DeKalb County Historic Preservation Commission

Staff Report

E. 971 Oakdale Road, FIELD Landscape Architecture. Install landscaping. **1247562**

August 2025

PROPERTY LINE SCREEN PLANTING
SCALE: 1" = 20'-0"

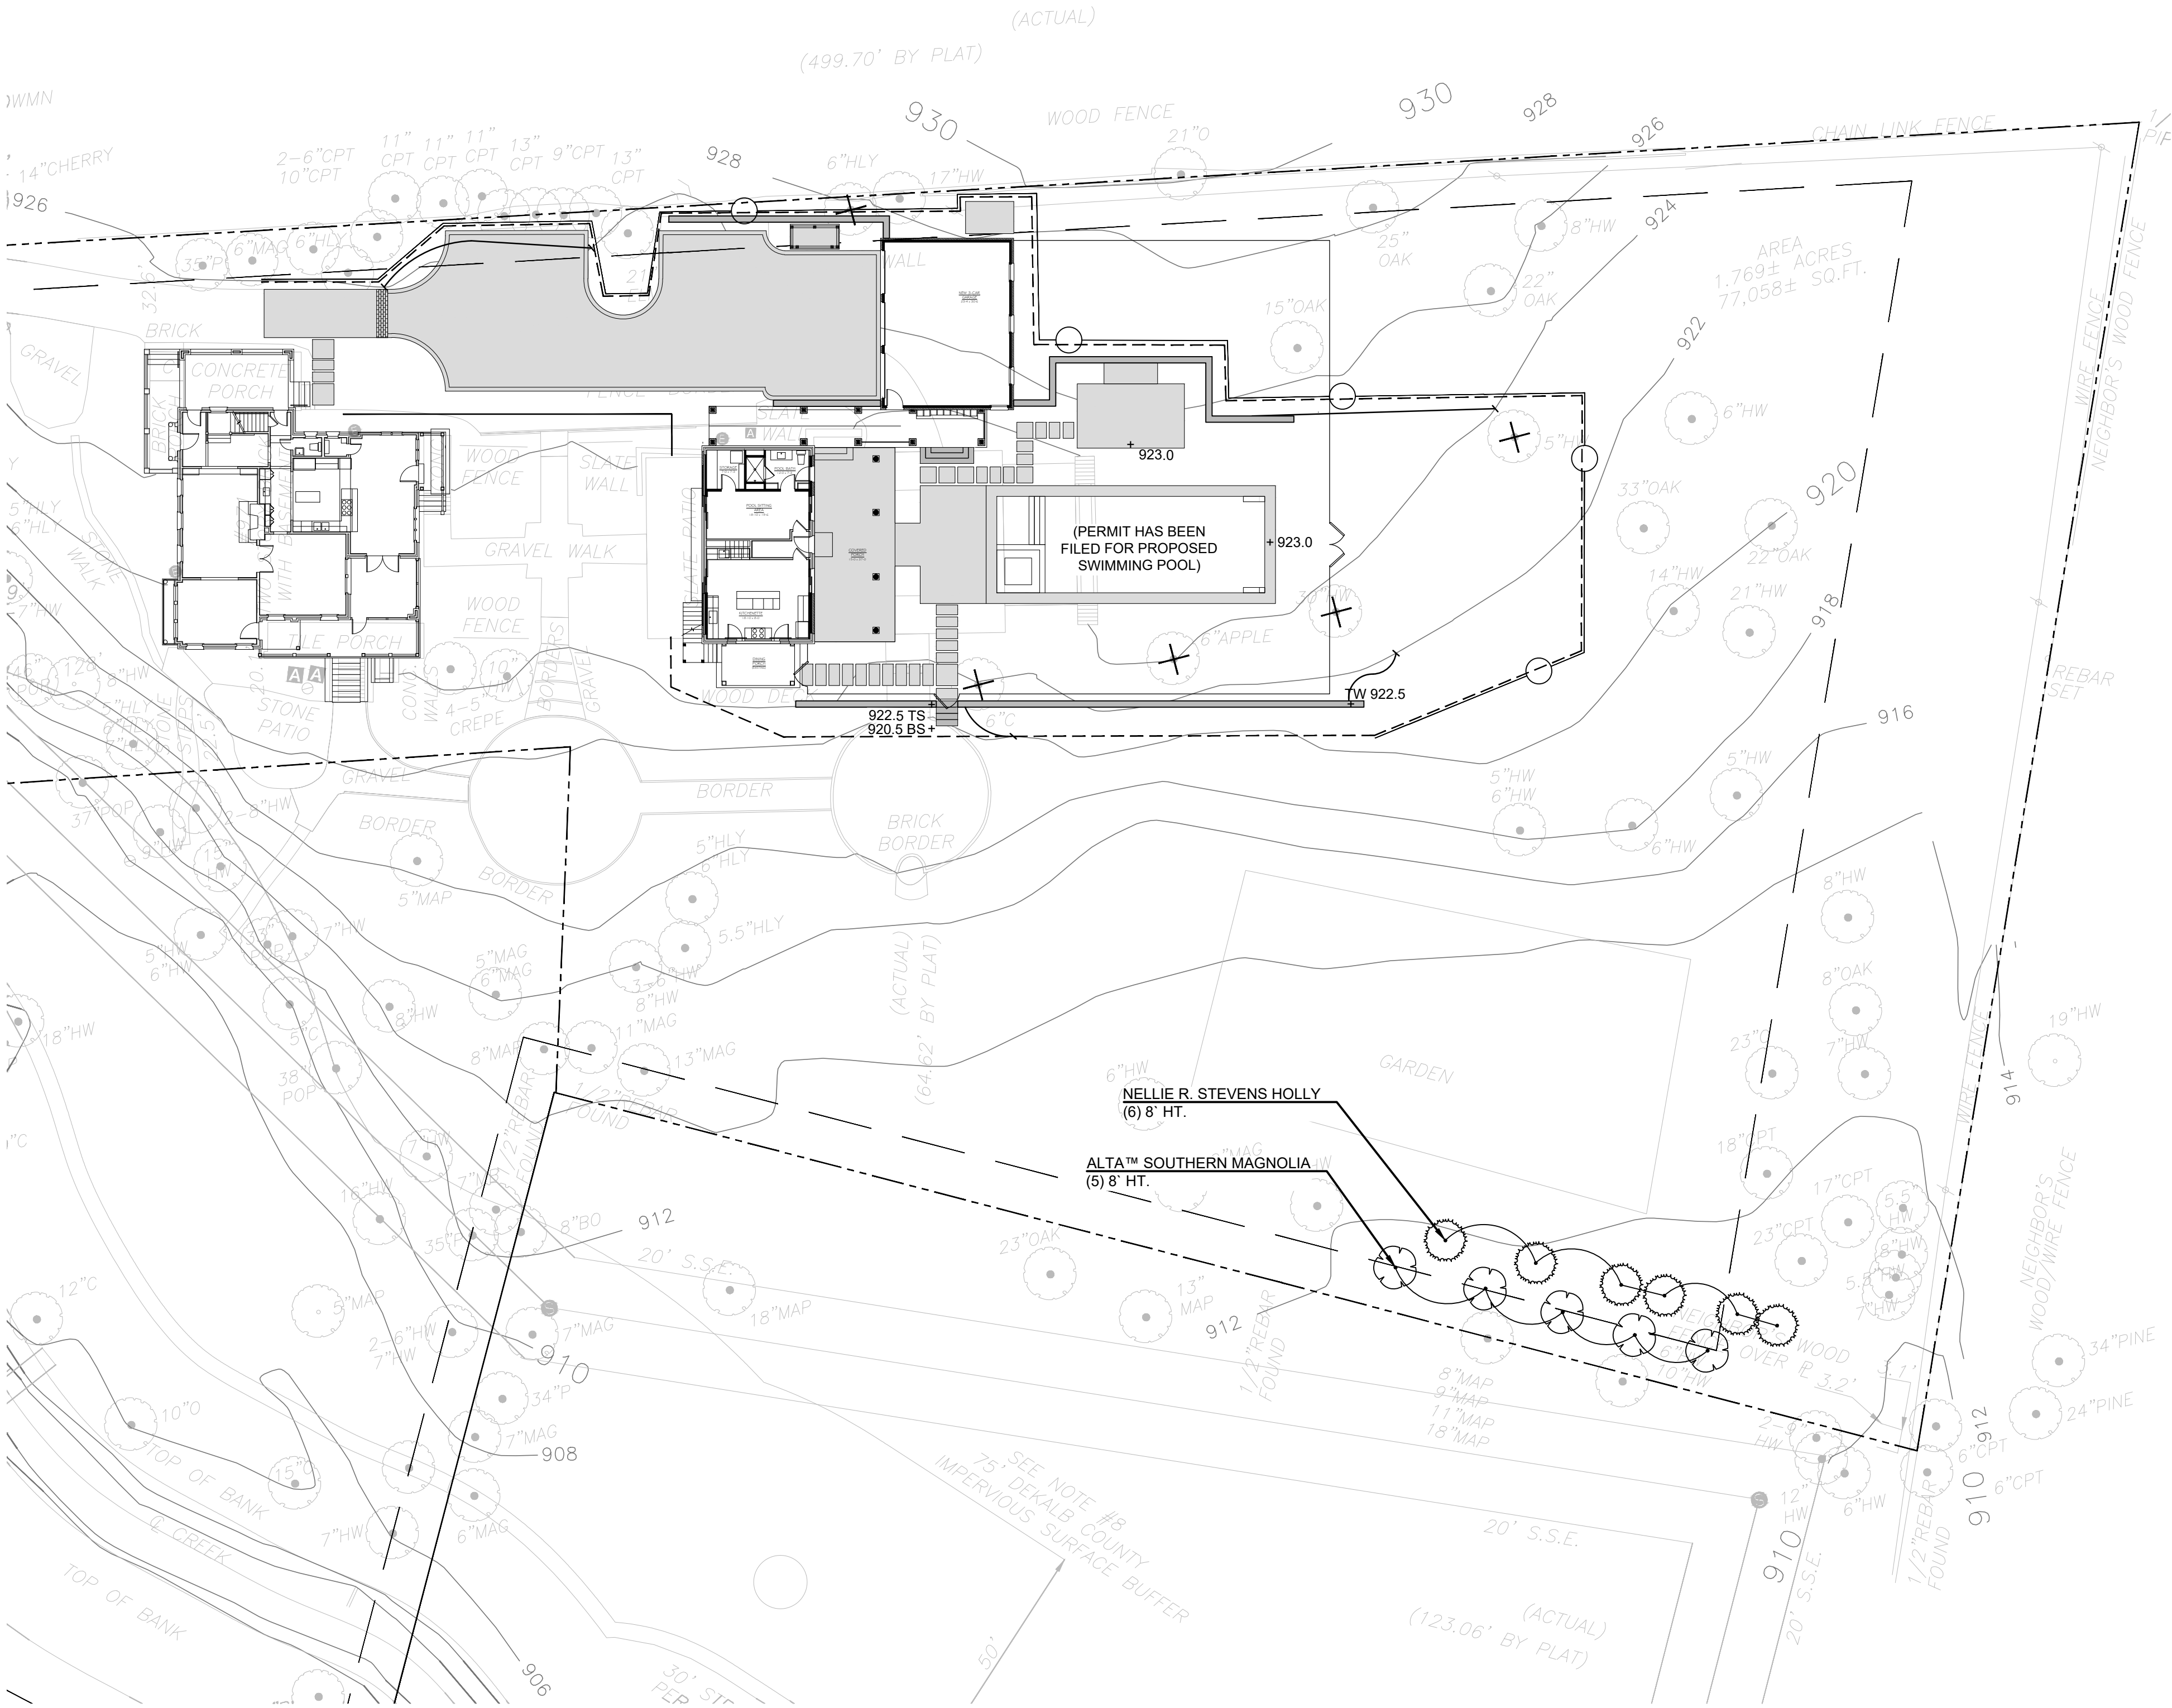
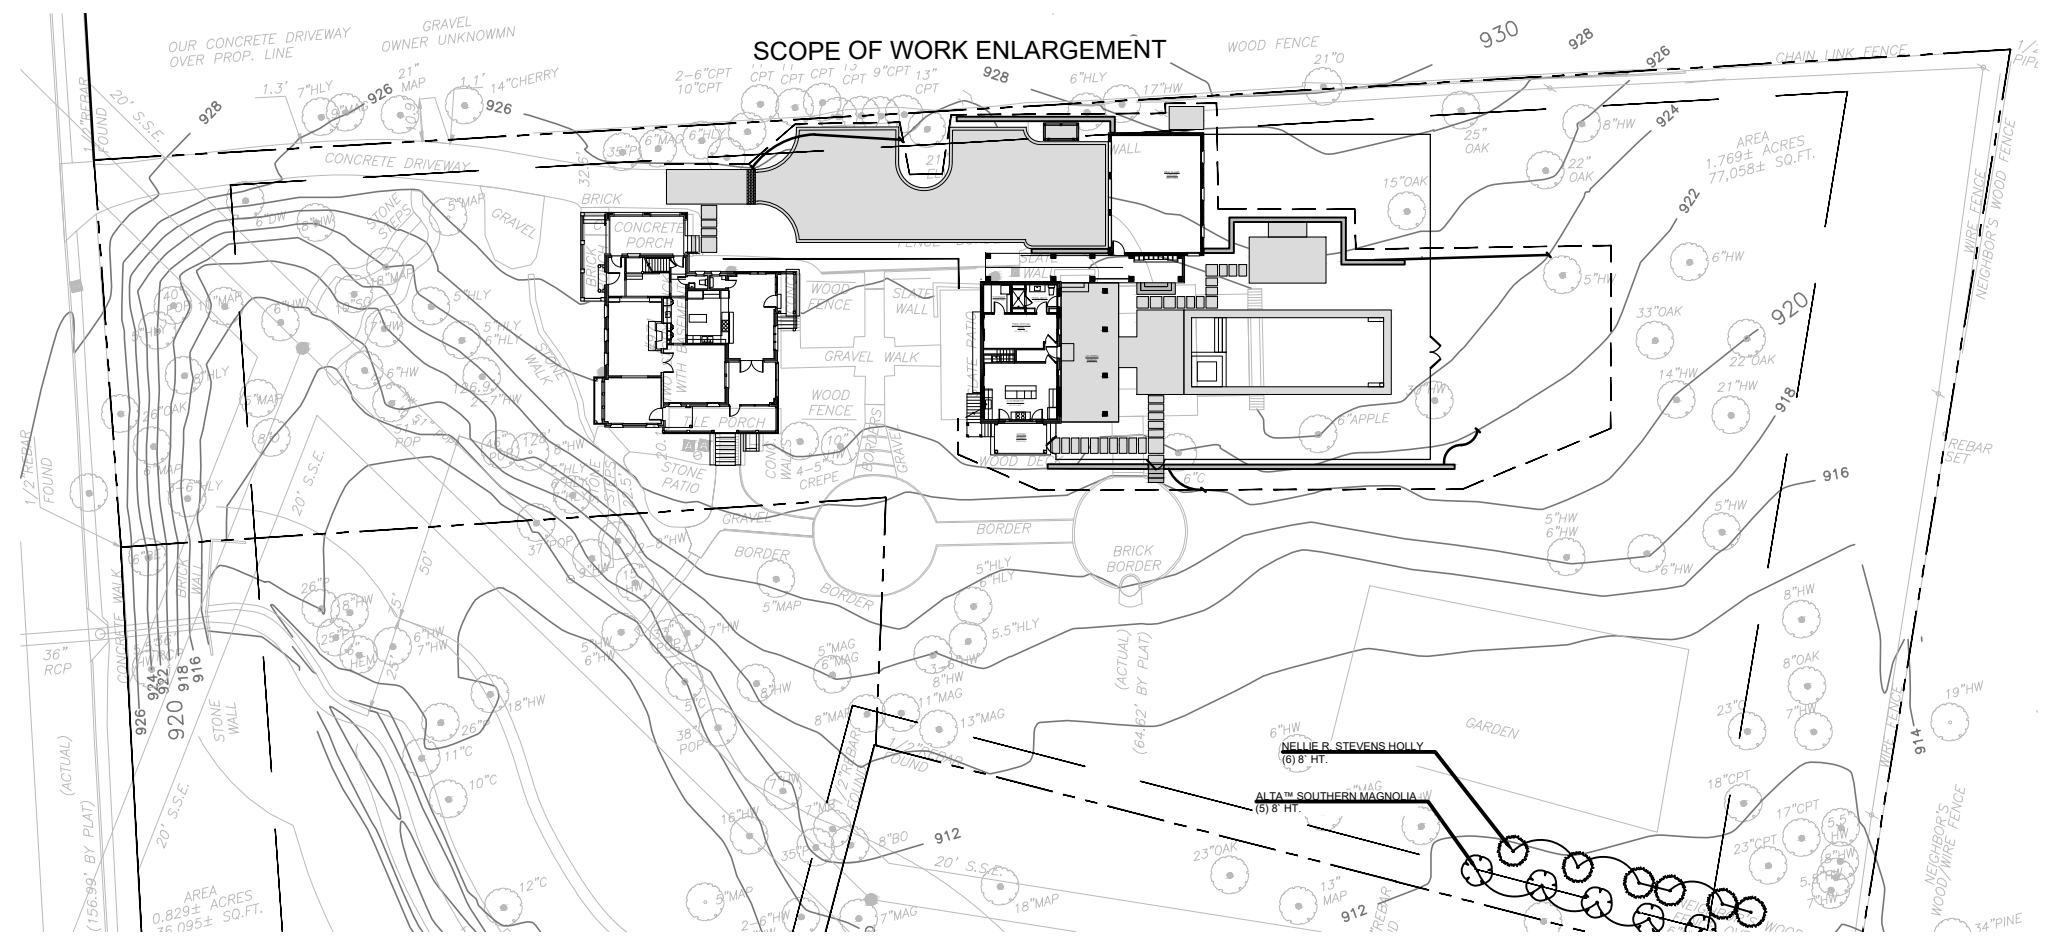
The application documents are unclear as to specifically what will be planted along the border between 971 Oakdale & 1366 The By Way.

Mr Kinsell confirmed that the plans will be modified to show those plantings will be

- 1) EVERGREEN and
- 2) be with typical heights of 15-20 FEET and
- 3) be of an interspersed variety of a few species and
- 4) be planted in a natural, off-center staggered fashion.

The applicant provided a screen planting plan. This planting plan includes the planting of 5 "Nelly R. Stevens Holly" bushes and 4 Southern Magnolia bushes in the rear-right corner of the property, along the Southern property line shared with the properties at 1354 and 1366 The By Way. The plantings will be installed in a staggered manner, with the Southern Magnolias closest to the property line and the Holly bushes closer to the main structure. Both proposed plantings are listed on the recommended vegetation list within Section 9 of the Druid Hills Design Manual.
